G0.10 --- CODE ANALYSISREVISED SUBMITTAL - PL20220623

G0.10 --- CODE ANALYSISORIGINAL SUBMITTAL - PL20220623

The Amble

The Amble Steamboat, CO

A0.01-A0.02 --- SITE PLANS REVISED SUBMITTAL - PL20220623

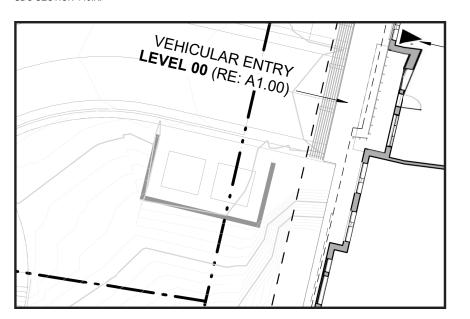
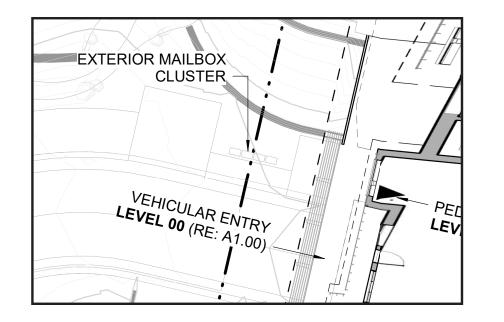
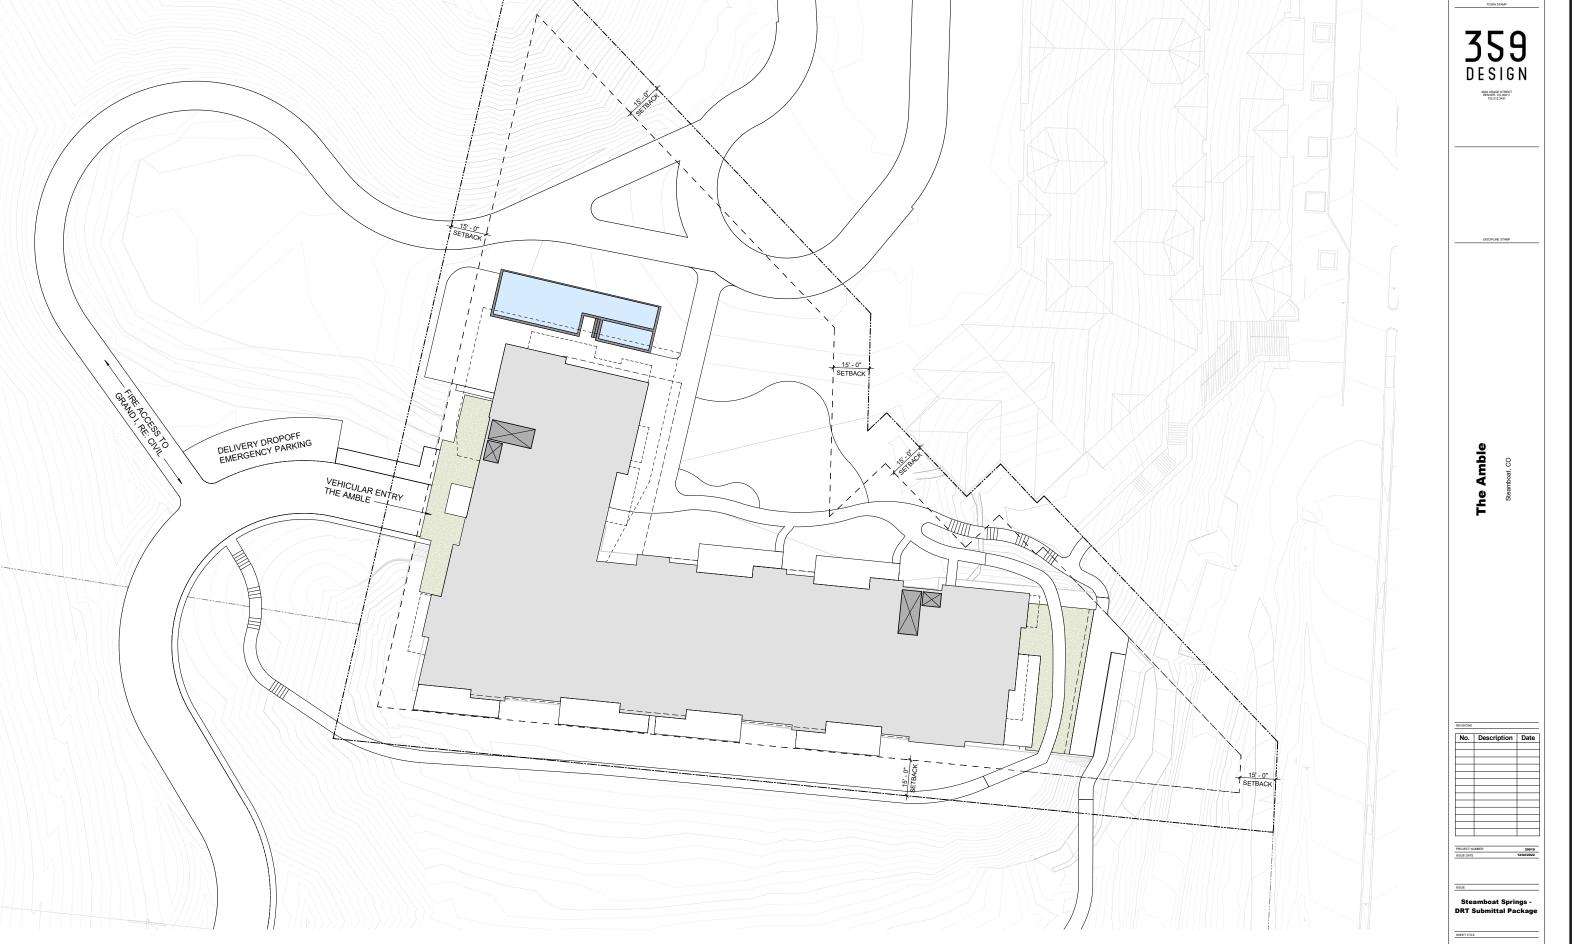
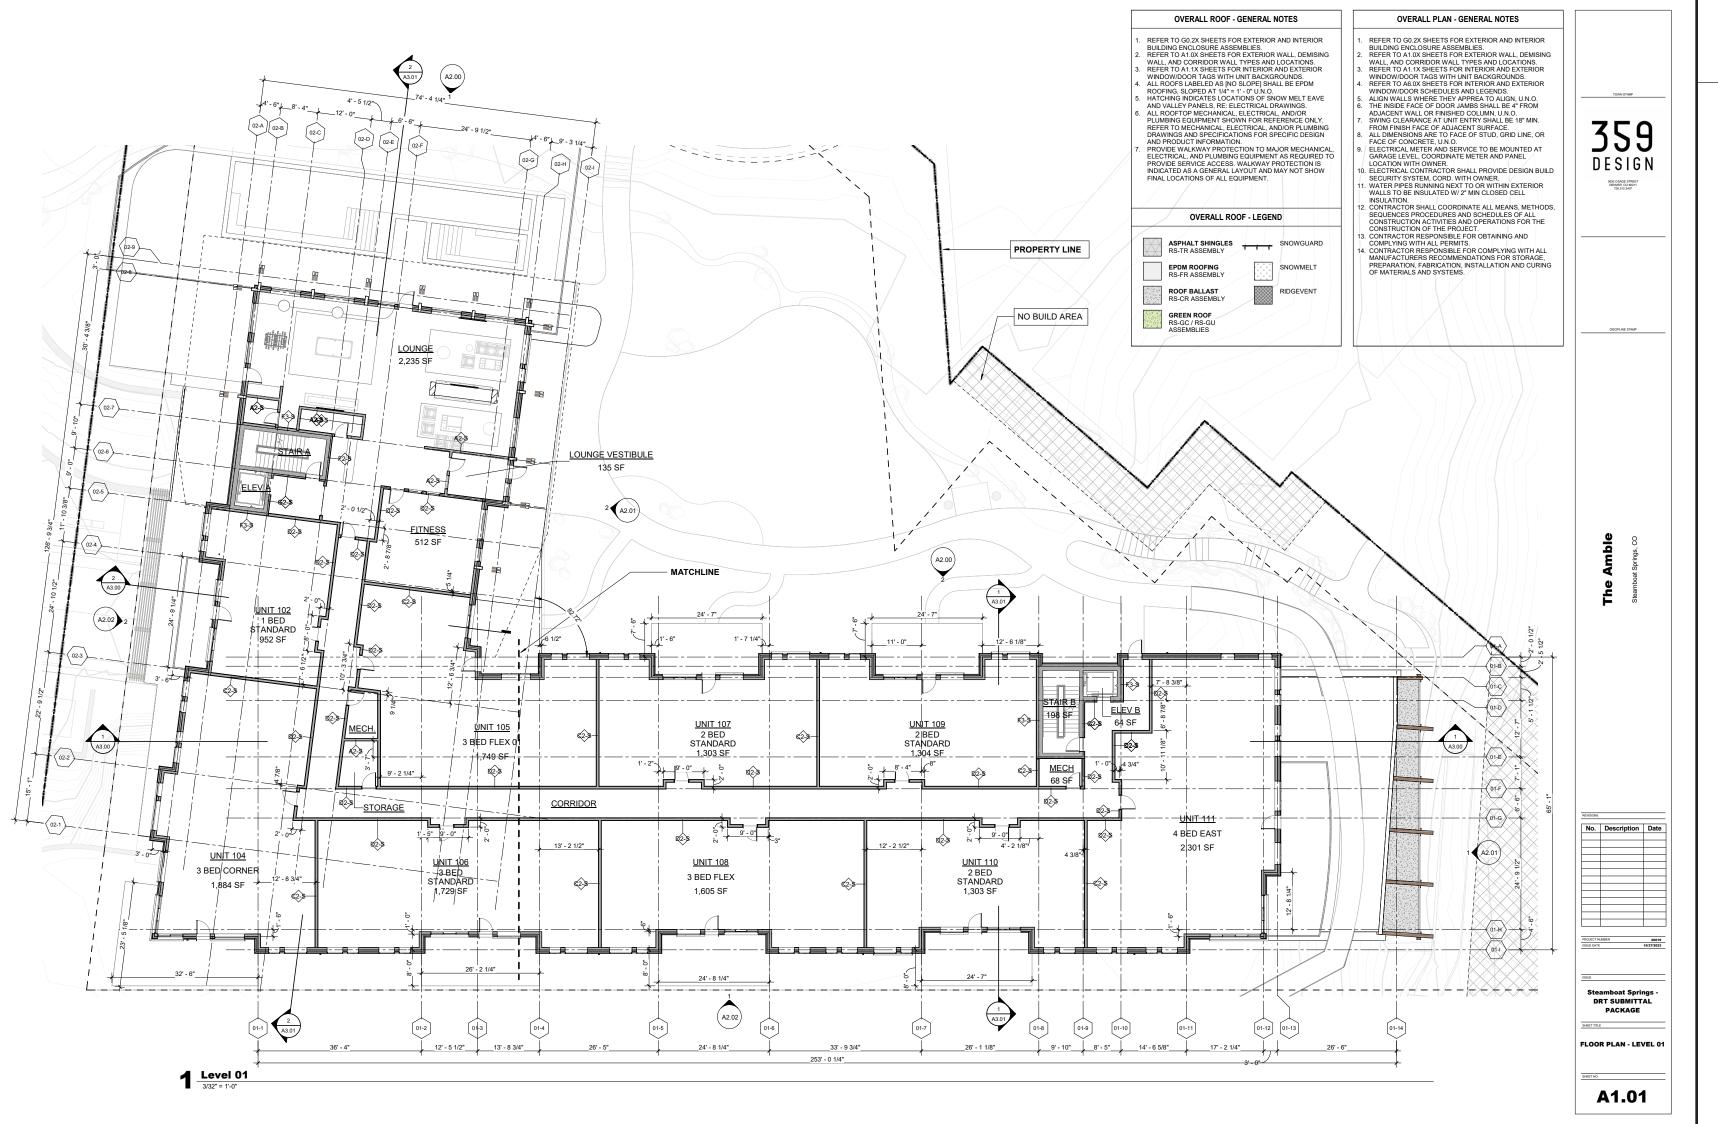
- 01. SHEET NUMBER CHANGED FROM A0.12 TO A0.02.
- 02. MINOR ADJUSTMENTS TO THE OVERALL BUILDING FOOTPRINT. THIS RELATES TO THE CHANGED SITE COVERAGE NOTED ON PAGE 01 OF THIS PDF.
- 03. NO BUILD AREAS ARE NOW HIGHLIGHTED.
- 04. AS HIGHLIGHTED BELOW, A LOCATION FOR TWO TRANSFORMERS HAS BEEN ADDED TO THE SITE PLAN. THIS CONSTRUCTED OF MATERIALS REFLECTING THE OVERALL CHARACTER OF THE BUILDING, WILL BE USED IN FRONT OF THE TRANSFORMERS TO SCREEN THEM FROM VIEW, MEETING THE REQUIREMENTS OUTLINED PER

05. AS HIGHLIGHTED BELOW, AN EXTERIOR LOCATION HAS BEEN ADDED FOR MAIL DELIVERY. THIS LOCATION HAS BEEN COORDINATED WITH THE LOCAL USPS AND MEETS THE REQUIREMENTS OUTLINED PER SDC SECTION

A1.00-A1.05 --- OVERALL PLANS REVISED SUBMITTAL - PL20220623

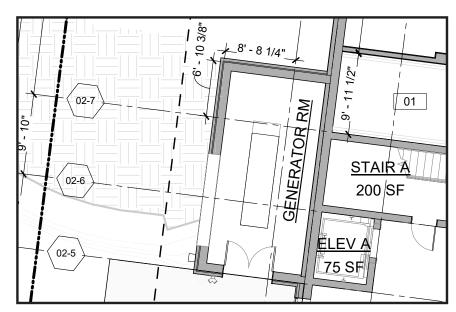
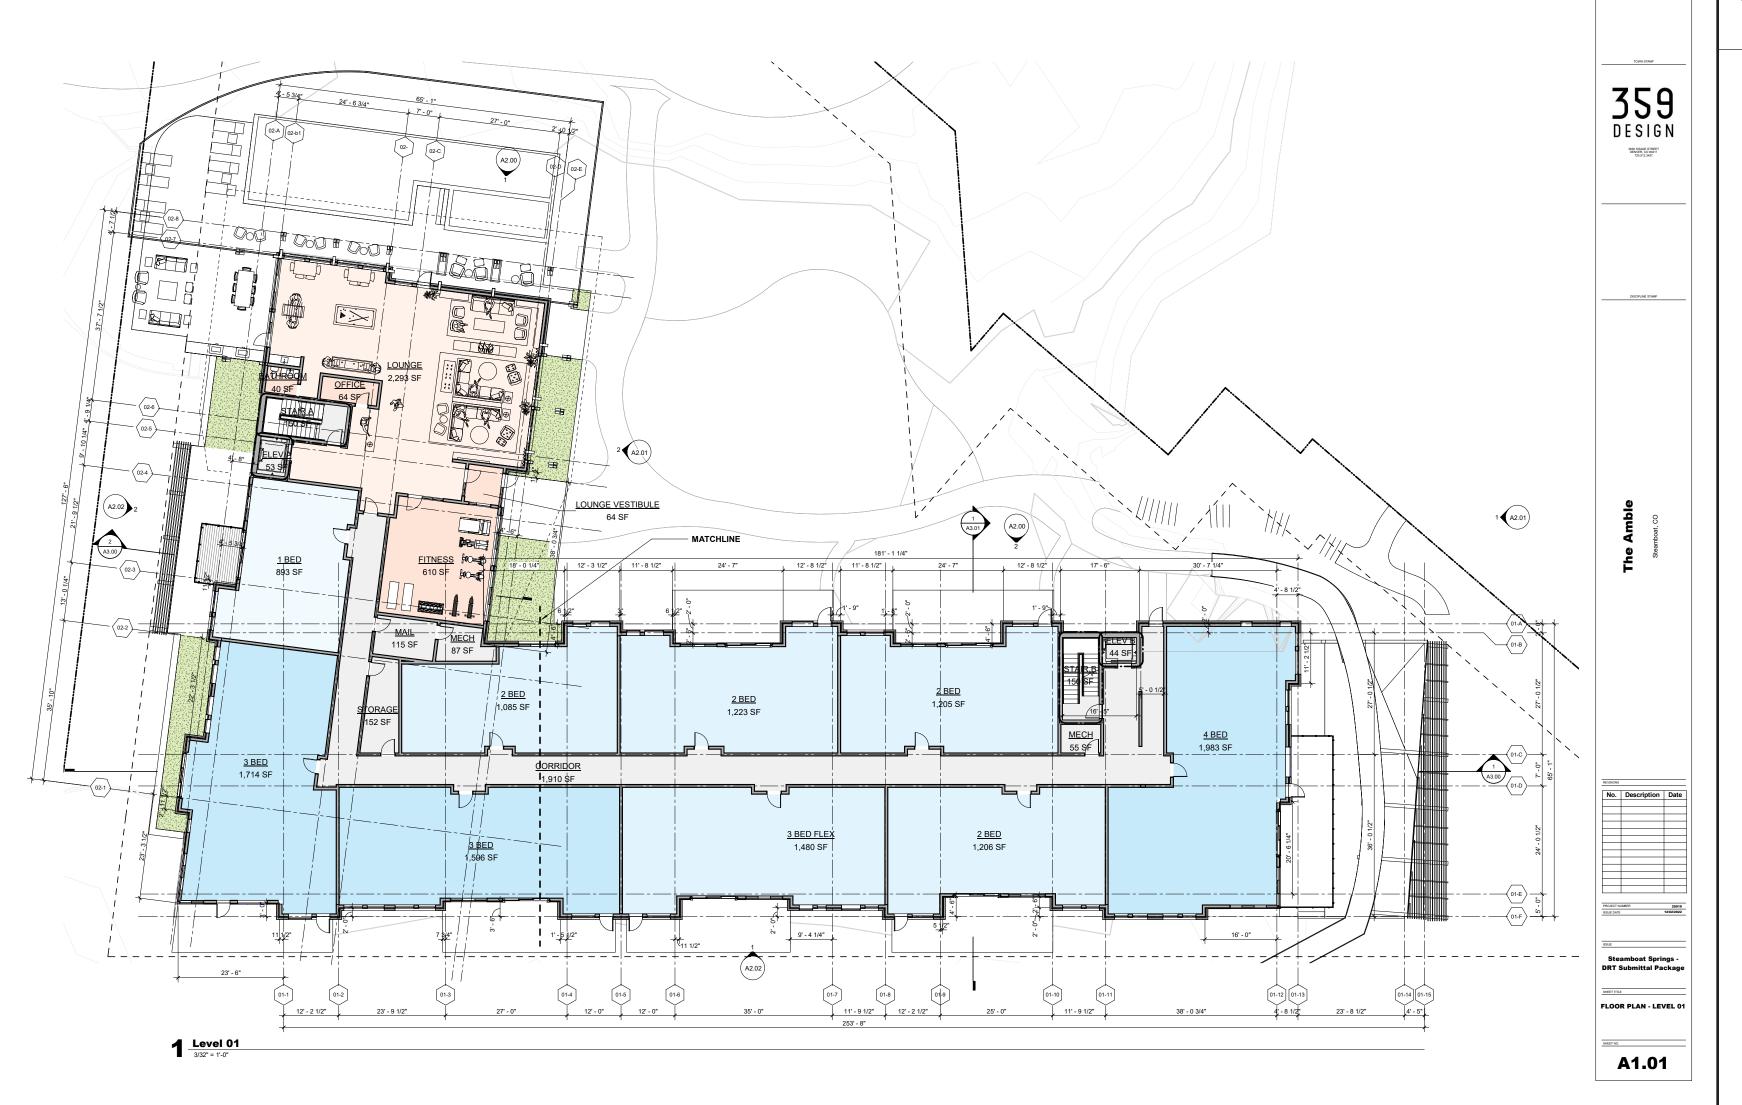
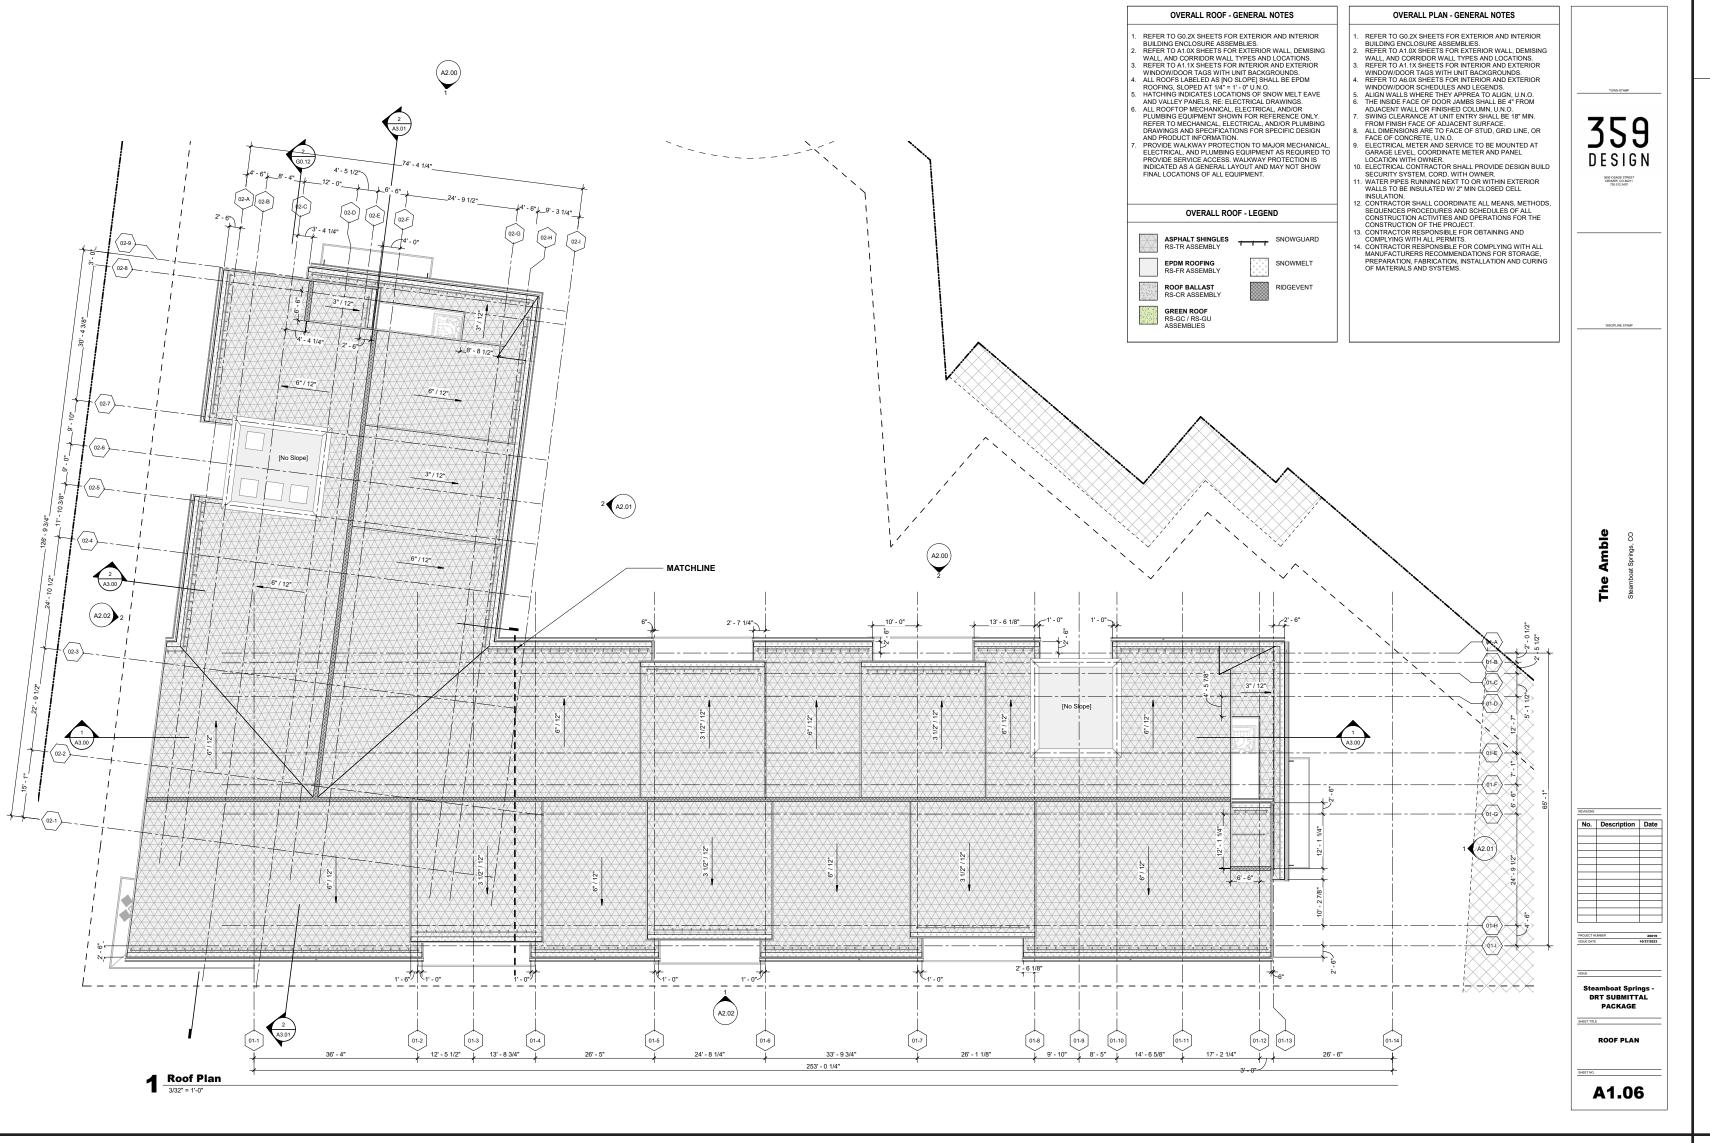
- 01. MINOR ADJUSTMENTS TO INTERIOR LAYOUT, RE: PAGE 02 OF THIS PACKAGE AS WELL AS THE REVIEW OF GSF AND NSF PAGES.
- 02. A1.00 (NOT PREVIEWED HERE) SHOWS AN ADDED GENERATOR LOCATION, HIGHLIGHTED BELOW. THIS GENERATOR LOCATION IS CONNECTED TO THE PRIMARY BUILDING MASS, WITH EXTERIOR MATERIALS MATCHING THE SURROUNDING EXTERIOR MATERIALS OF THE PRIMARY BUILDING FORM. ACCESS IS PROVIDED FROM THE DRIVE AISLE, WITH EXAUST LOUVERS, COLORED DARK BRONZE TO MATCH OTHER ARCHITECTURAL ELEMENTS ON THE BUILDING FACADE, LOCATED ON THE WEST FACE OF THE ENCLOSURE. THE DESIGN OF THIS GENERATOR ENCLOSURE IS INTENDED TO MEET THE REQUIREMENTS AS OUTLINED IN THE SDC SECTION 440.K.
